**FEDERAL HIGHWAY ADMINISTRATION
FINDING OF NO SIGNIFICANT IMPACT
FOR**

Columbus Viaducts Project
Platte County, Nebraska

FINAL ENVIRONMENTAL ASSESSMENT

SUMMARY FINAL ENVIRONMENTAL ASSESSMENT – ERRATA TO DEA

DATE	May 2011
FIGURE	2

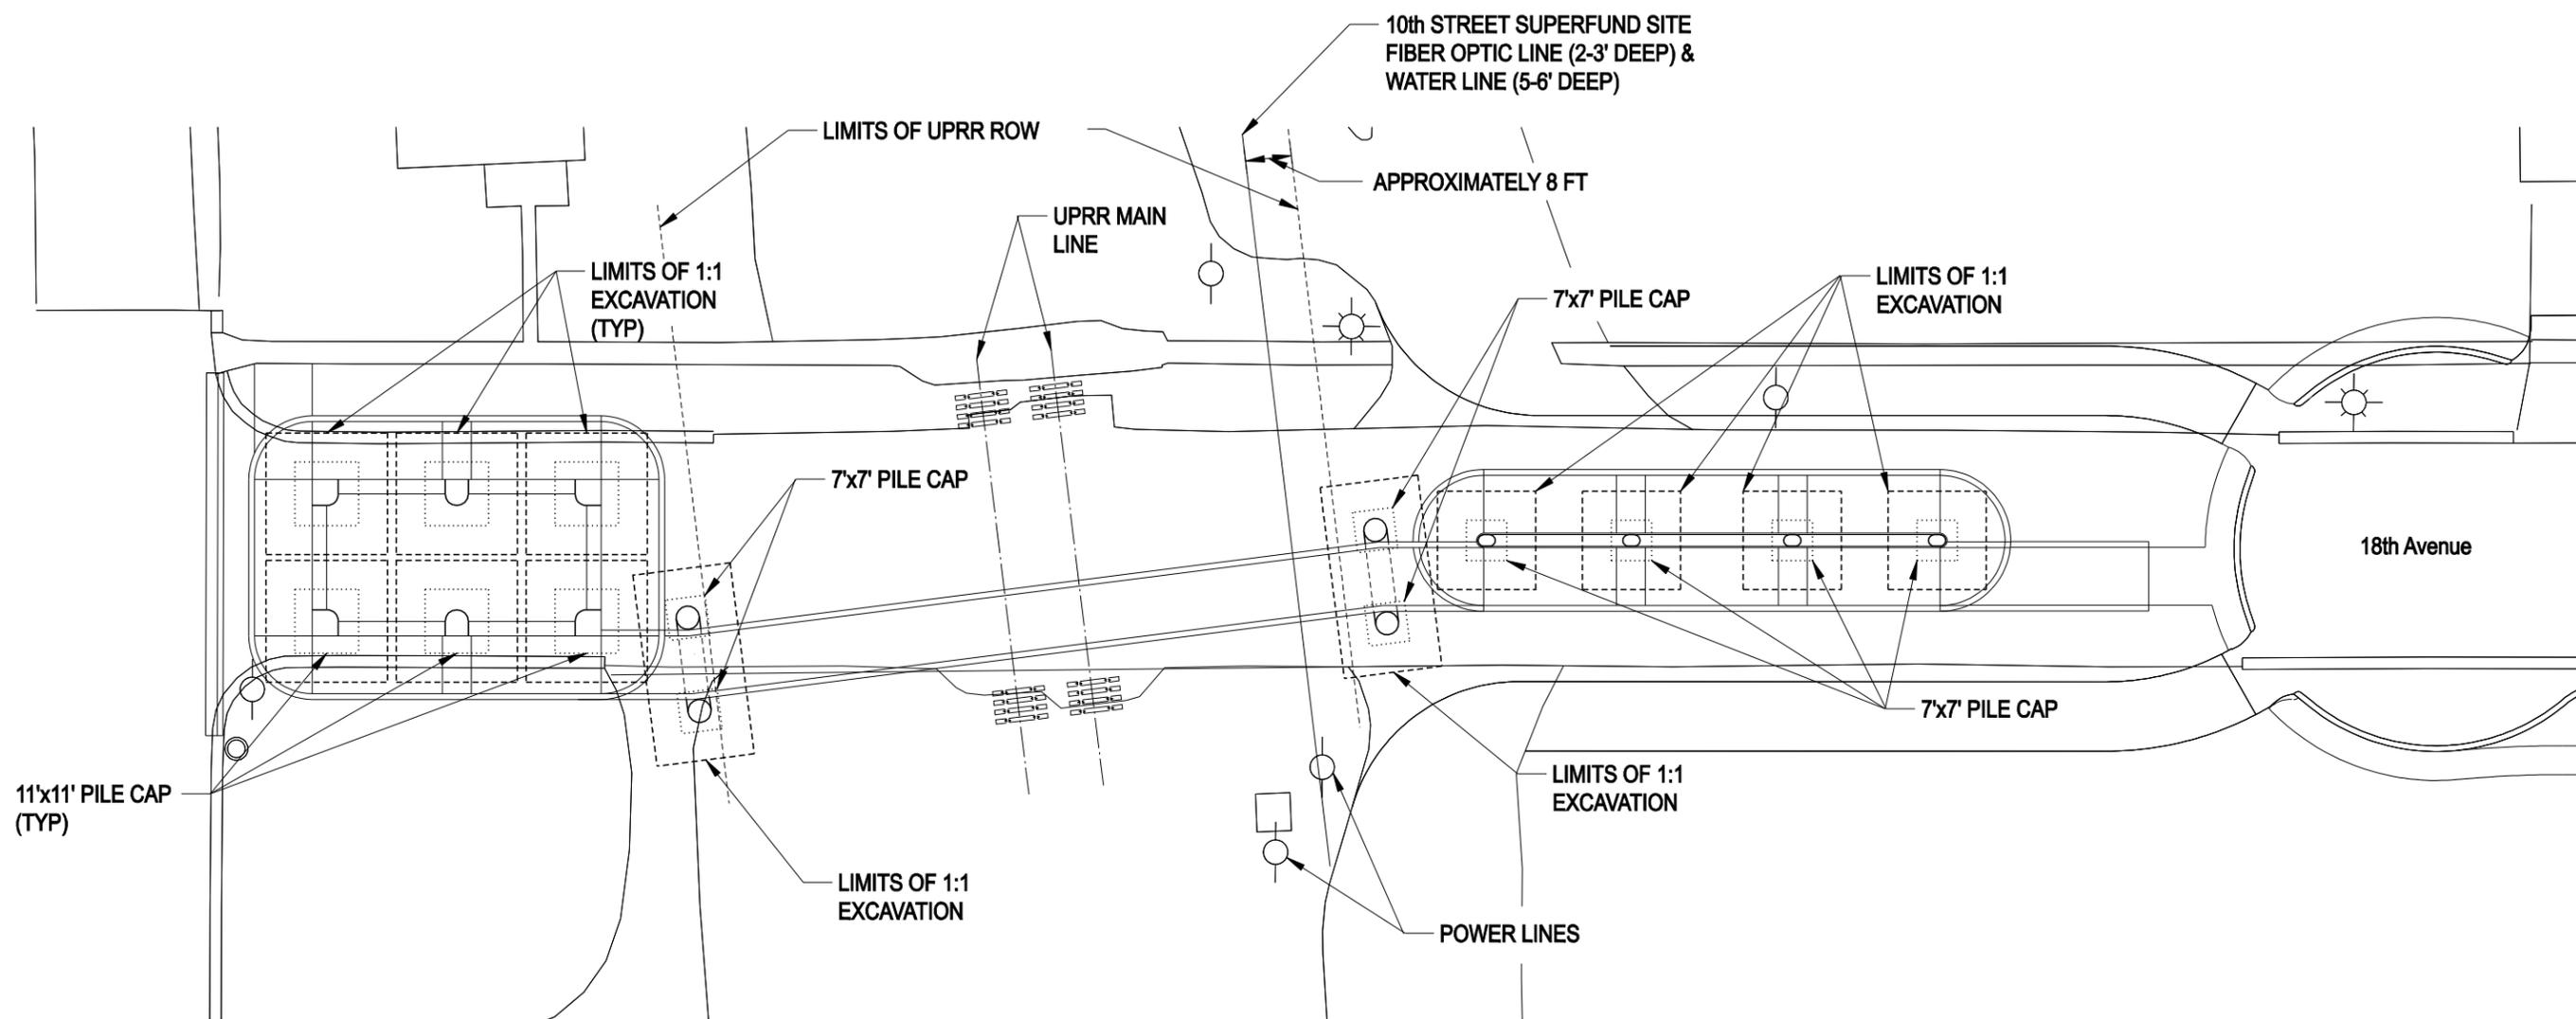
~~excavations that could require acquisition of additional construction easements or permanent ROW beyond the 18th Avenue ROW. Based on the bearing loads of the soils and underlying alluvium, the bottom of the footings should be placed at a depth of 10 feet. Additional excavation (up to 3.5 feet deeper) may be needed to remove clay that extends to a depth of approximately 13 feet. Excavations for the foundations will require, at a minimum, a 1:1 slope – for every foot of depth, the excavation will extend 1-foot horizontally in each direction. Consequently, a 10-foot excavation will extend 10 feet horizontally from each side of the spread footings.~~

Vertical and lateral loads were estimated for the pedestrian bridge columns as part of the preliminary design. Four columns, aligned north to south, will be needed on the north approach ramp. A 17-foot by 15-foot spread footing will be required for each column (see **Figure 2**). A single excavation measuring approximately 118 feet (north to south) by 37 feet (east to west) will be needed for these footings.

3

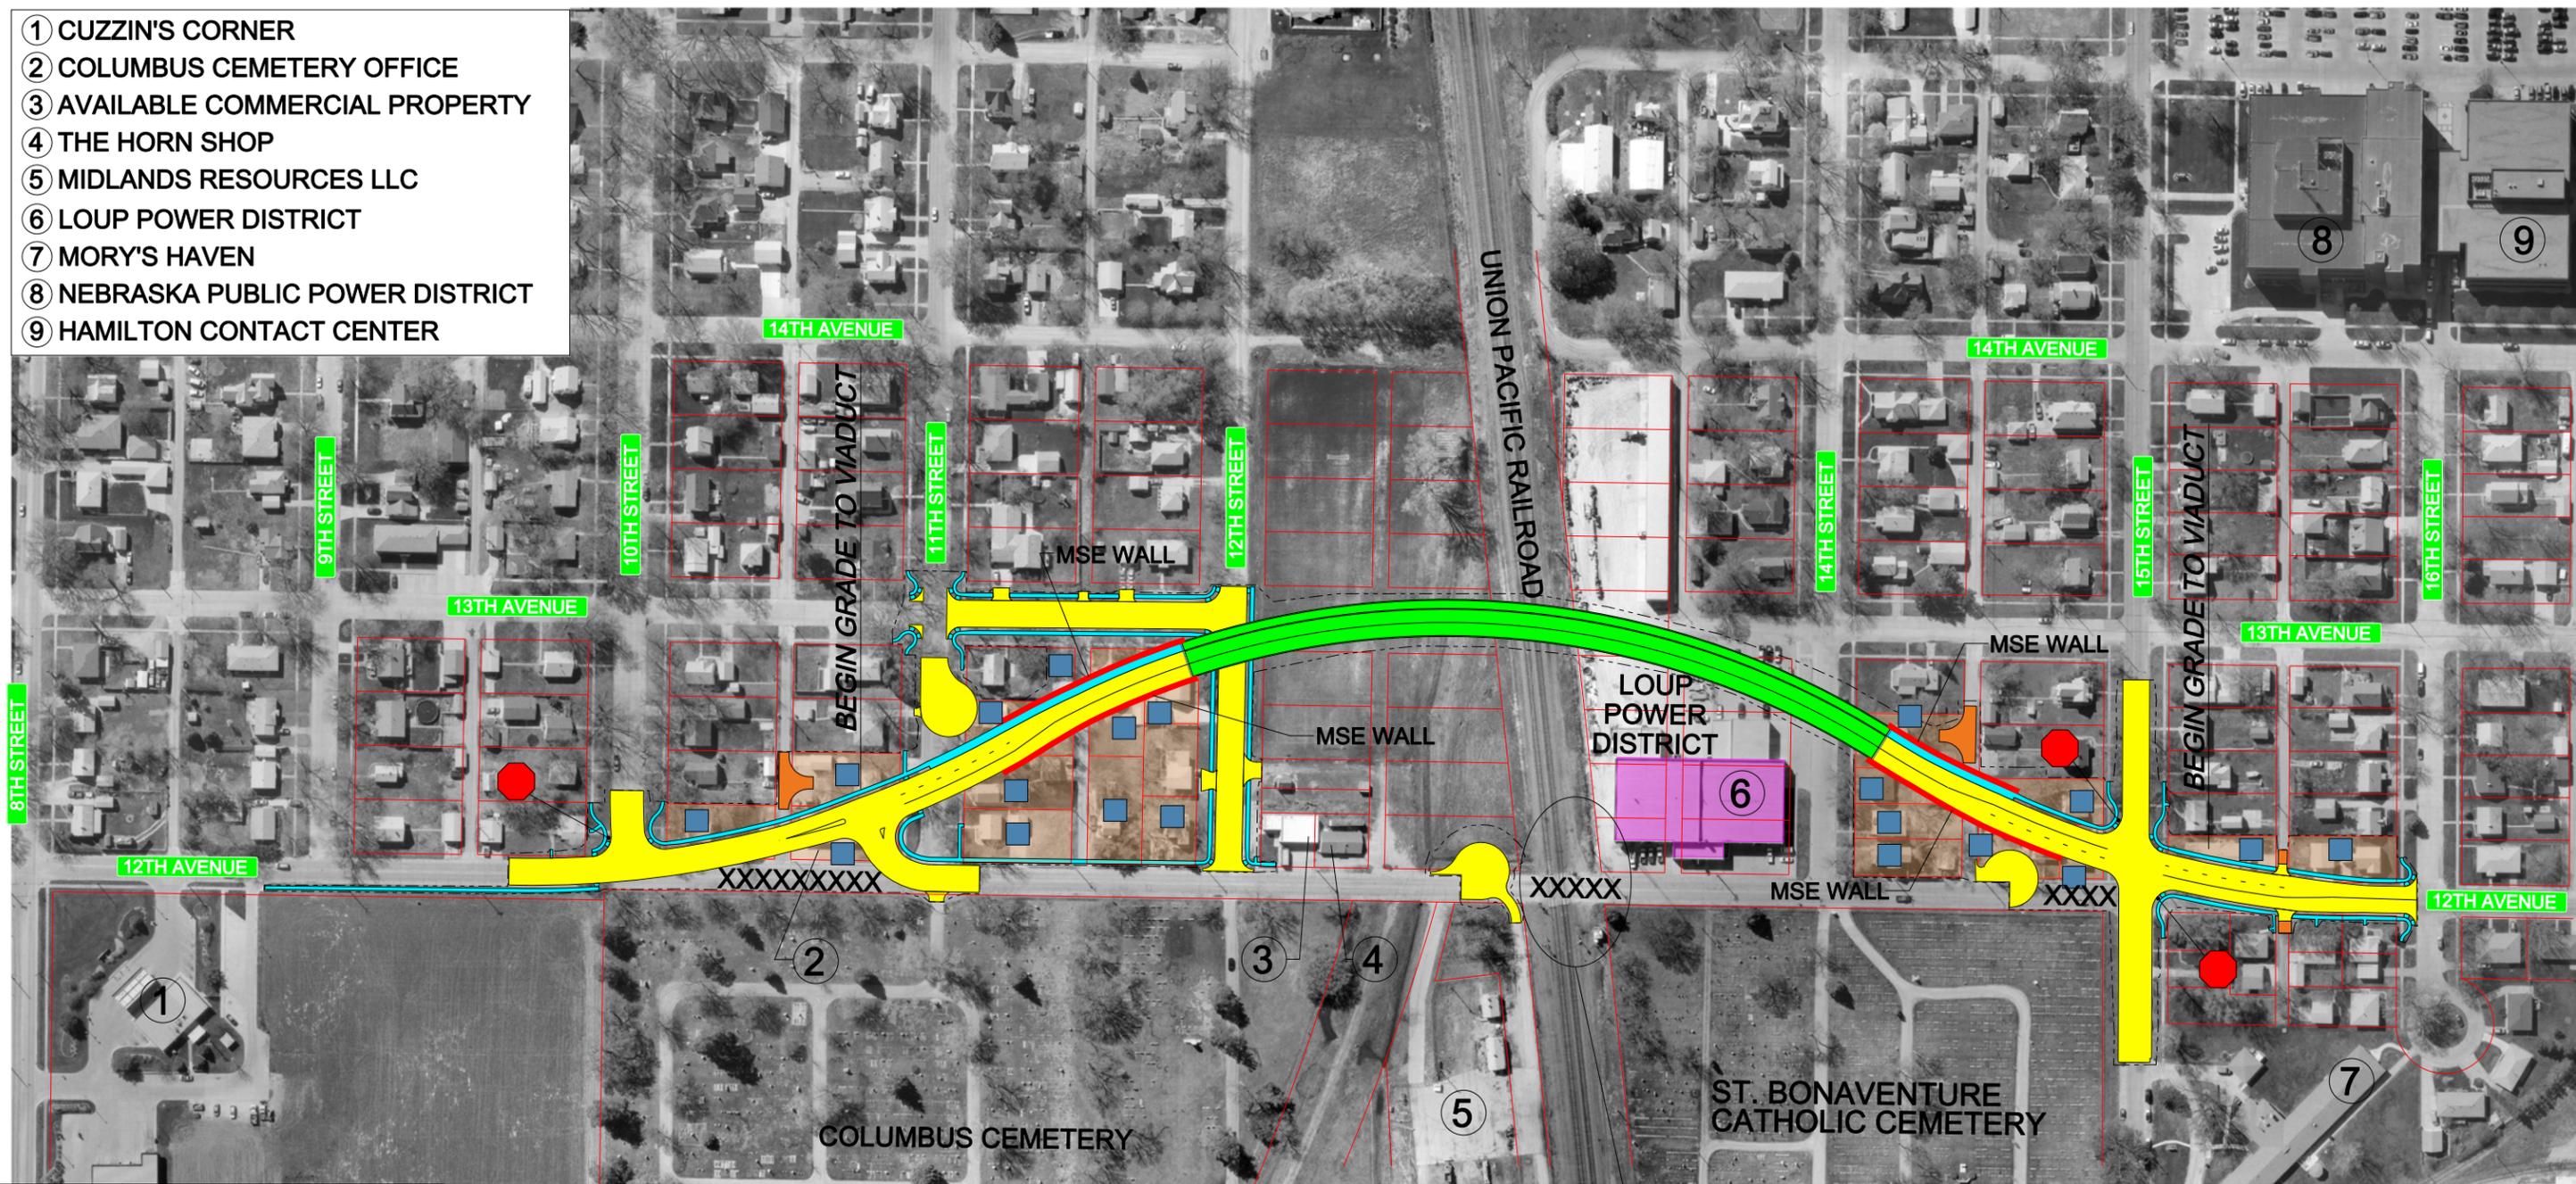
For the columns on the north approach ramp, either a 6-foot by 6-foot or 7-foot by 7-foot pile cap will be required, depending on whether precast concrete piles or steel pipe piles were used. Each pile cap will have four piles under it. The north approach ramp will require a total of four columns and foundations. Each of the excavations for the north approach ramp columns will extend out approximately 17 feet by 17 feet, assuming a 5-foot deep excavation (see **Figure 3**).

FIGURE
 3-3

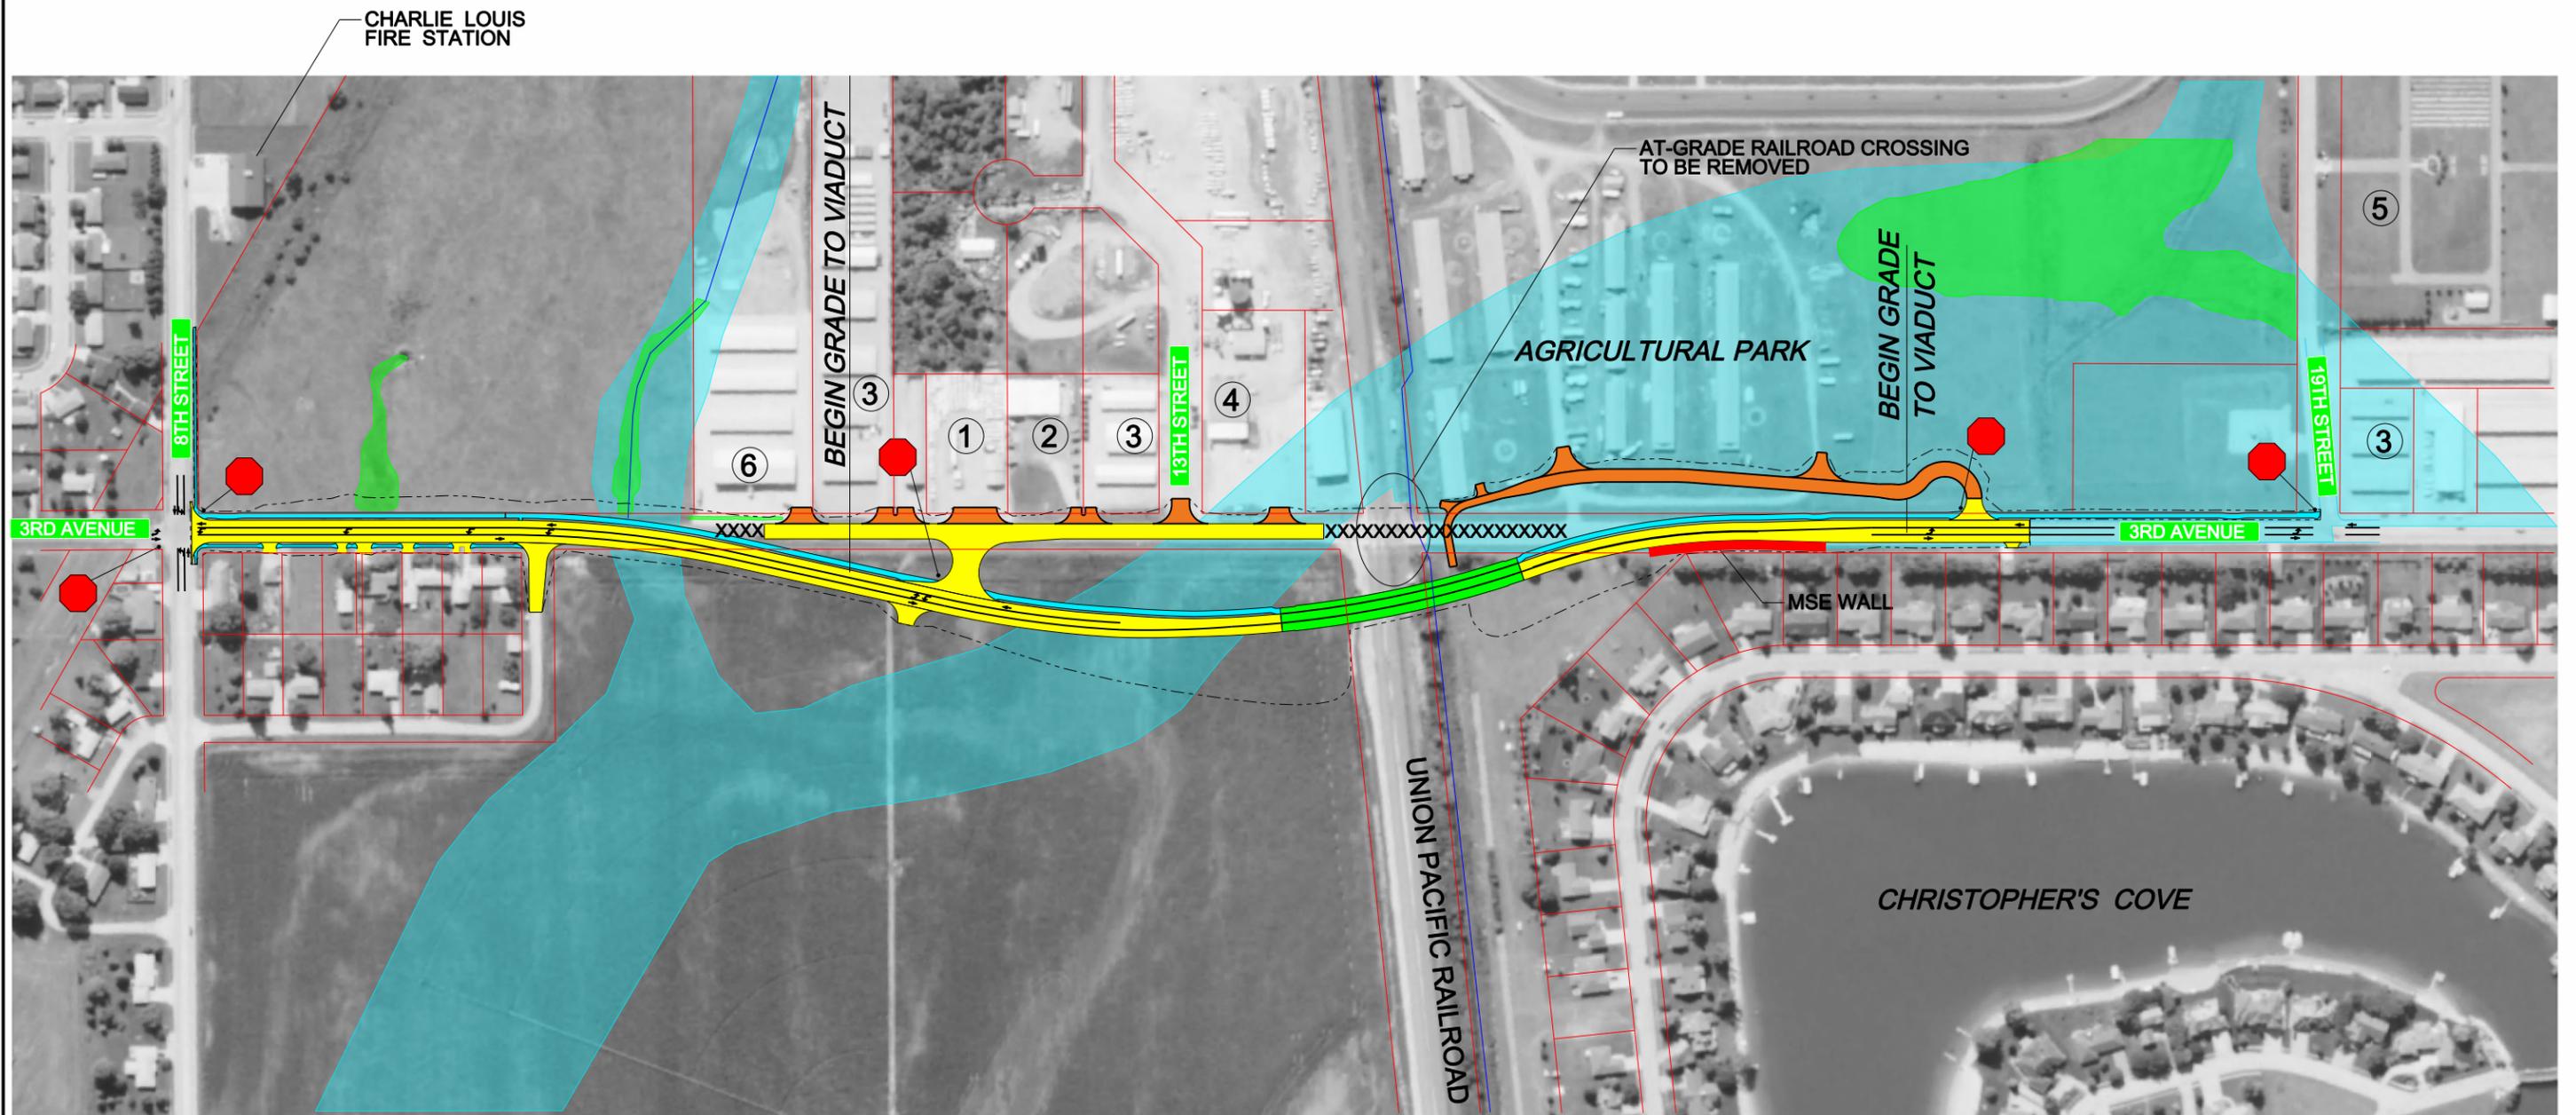
Figure 3-3 was updated to reflect changes in businesses within the 12th Avenue corridor.
